Access Compliance Report

Public Rights-of-Way

(Curb Ramps)

Intersection ID: 4708	Main Street: N_TRYON_ST	Cross Street: US_29_ACCESS_RD	Location: W
ADA ID: 117C79B3BDA9	Ramp Type: Perp	Initial Pass/Fail: Fail	Overall Compliance: No
Severity Score: 25			
Codes/Mitigation Info/Possible Solution		Field Measurements/Component Compliance

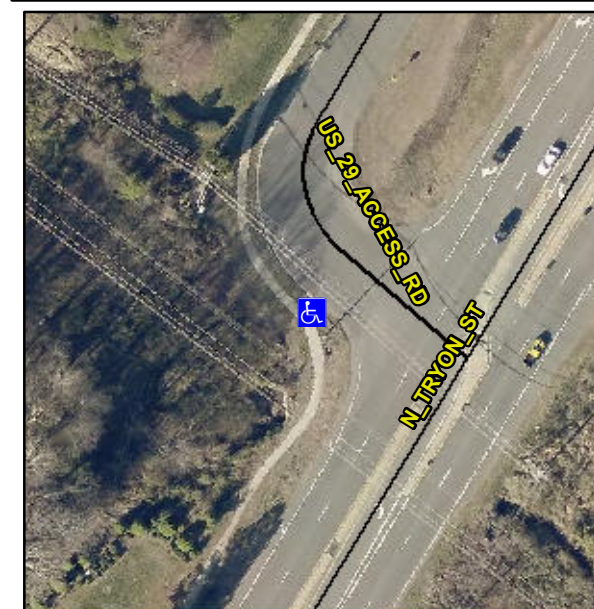
Compliance	Description	Data	Compliance	Description	Data
N/A	Ramp Length (in)	68.0	No	Ramp Slope (%)	20.0
Yes	Ramp Width (in)	48.0	Yes	Ramp XSlope (%)	0.5
N/A	Flare Type LT	N/A	N/A	Flare Type RT	N/A
N/A	Flare Slope LT (%)	N/A	N/A	Flare Slope RT (%)	N/A
N/A	Flare Traversable LT?	N/A	N/A	Flare Traversable RT?	N/A
N/A	Landing Length (in)	N/A	N/A	DWS Provided?	N/A
N/A	Landing Width (in)	N/A	N/A	DWS Contrast?	N/A
N/A	Landing Slope (%)	N/A	N/A	DWS Length (in)	N/A
N/A	Landing X Slope (%)	N/A	N/A	DWS Full Width?	N/A
N/A	Landing Curb? (Y/N)	N/A	N/A	DWS Offset (in)	N/A
N/A	Shared Landing?	N/A			
N/A	Gutter Ponding?	N/A	N/A	Gutter Slope (%)	N/A
N/A	Gutter Lip Ht (in)	N/A	N/A	Gutter X Slope (%)	N/A
N/A	Painted X Walk1?	No	N/A	Painted X Walk2?	N/A
	X Walk 1 Direction	To NE		X Walk 2 Direction	N/A
N/A	X Walk 1 Width (in)	N/A	N/A	X Walk 2 Width (in)	N/A
	X Walk 1 Slope (%)	1.4		X Walk 2 Slope (%)	N/A
	X Walk 1 X Slope (%)	2.6		X Walk 2 X Slope (%)	N/A

Remove & Replace Entire Ramp.

R304.2.2
